**Re: Backer Works, 5809 Jefferson St NE,
Request for Permanent C.O. –Accepted
Engineer's Stamp dated: 03-28-12, (E17/D018)
Certification dated: 07-31-12**

**Re: Backer Works, 5809 Jefferson St NE,
Request for Permanent C.O. - Disapproved
Engineer's Stamp dated: 03-28-12, (E17/D018)
Certification dated: 06-22-12**

Re: Backer Works, 5809 Jefferson NE
Grading and Drainage Plan
Engineer's Stamp date 3-28-12 (E17/D018)

ENGINEER'S SEAL	DAVID J. HESTER
BACKERWORKS MANUFACTURING LLC 5809 JEFFERSON	
GRADING AND DRAINAGE PLAN	
Hjo Grande Engineering 1000 GARDEN AVENUE, SUITE 200 ALBUQUERQUE, NM 87102	
DATE 8-22-11	SHEET 1
DATE 21103

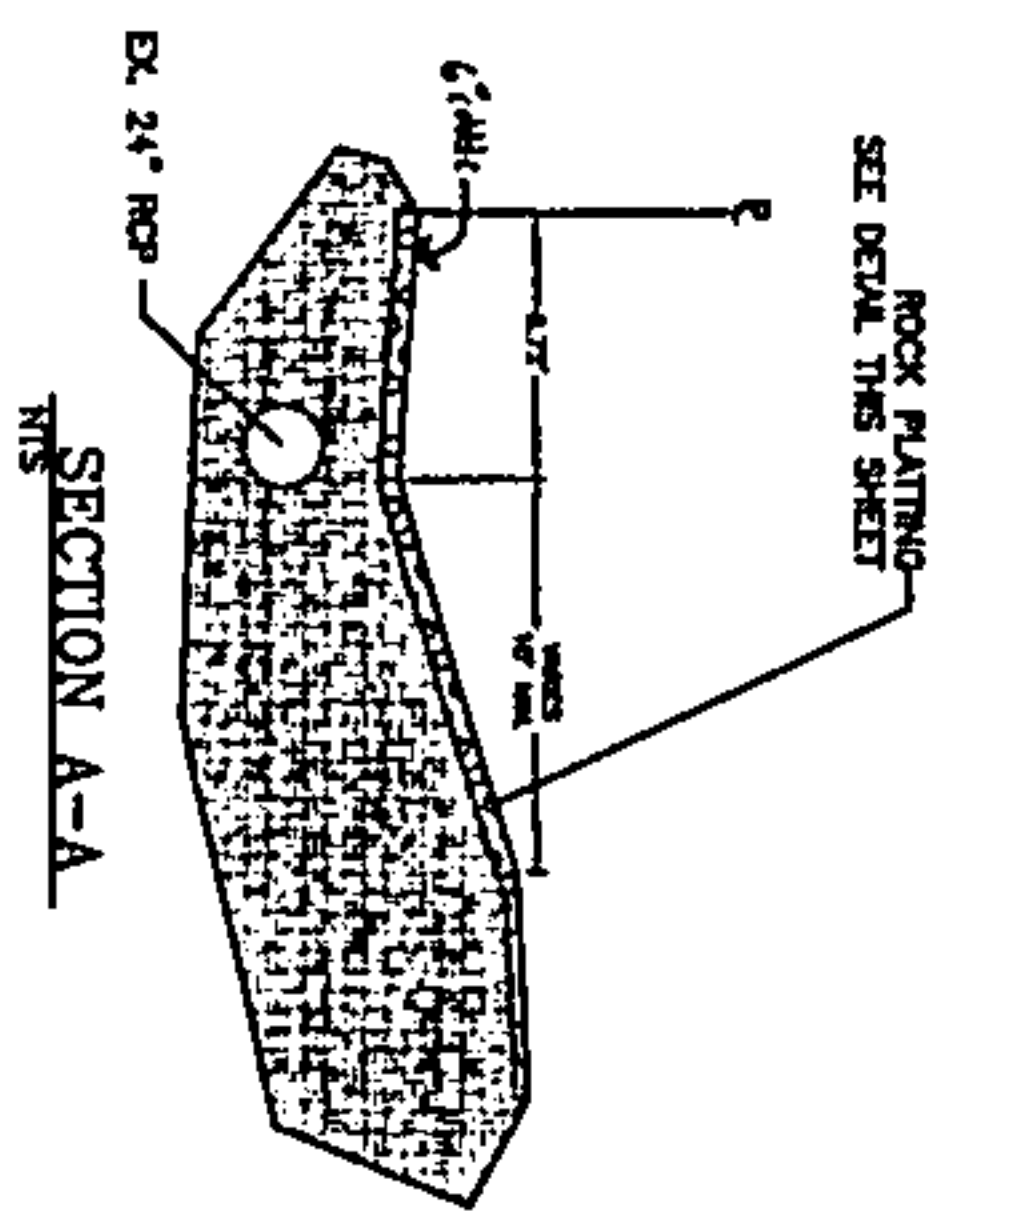
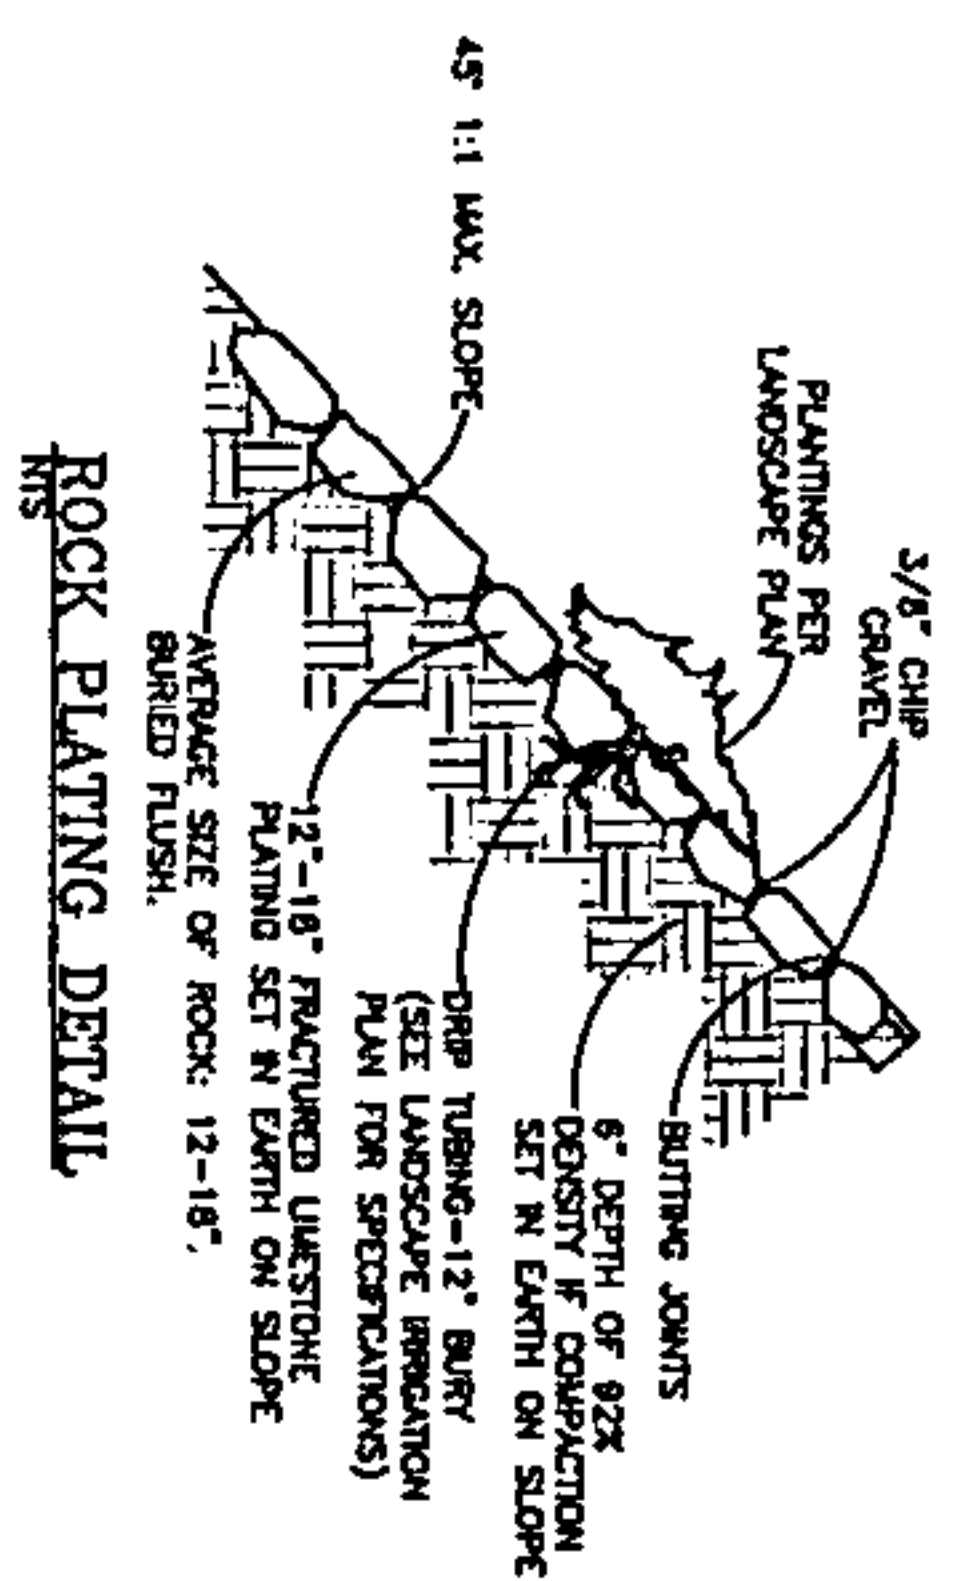
I did some research and investigation and cannot approve the referenced plan. It does not show some existing drainage features that I think should be shown. Please clarify and respond/revise/resubmit as necessary. The following items should be addressed:

1. The plat of the North Diversion Channel (NDC), Phase 4 (see attached portion of plat), shows a 60-foot east-west and 45-foot north-south private storm drain easement on the property.
2. The City Storm Facilities Maps (see attached portion) shows a 24-inch RCP outfall to the Bear Canyon Arroyo. I did not measure the pipe, but I think it is a 24-inch RCP, not a 36-inch CMP that is shown on the plan. It extends to the north to pick up runoff from adjacent properties. I verified Type D inlets marked 1 and 2 on the attached map. Inlet 3 is a slotted grate manhole that appears to be in the northwest corner of the Backerwerks property.
3. There is a low spot at number 4 full of tumbleweeds and vegetation. I did not dig it out in my field investigation. The City facilities map indicates that it might be a Type D inlet.

AMAFCA would like to see the low area around inlet 4 expanded to about 5 feet to the north to serve as a water quality ponding area. It should be lined with riprap. Also, place riprap to the property line next to the rock plating in Section A-A and from the end of the 12-inch PVC to the ponding area. If you have any questions, please call me at 884-2215.

The revised plan is acceptable to AMAFCA. I don't think we need to meet.

Lynn, I have attached the revised drawing. I have addressed your comments. The owner is pressing me to get an approval soon. He was a line backer for the New York Giants about 10 years ago, so I am extra motivated to keep him happy. Would you be able to review this, He asked if I could set up a meeting with you to go over. The comments were pretty straight forward. The easment you reference is on a lot west of us, and does not impact our site. The storm drain inlets have been shown and the water quality pond has been added. Please let me know if this is ok and if a meeting is warranted. Thanks
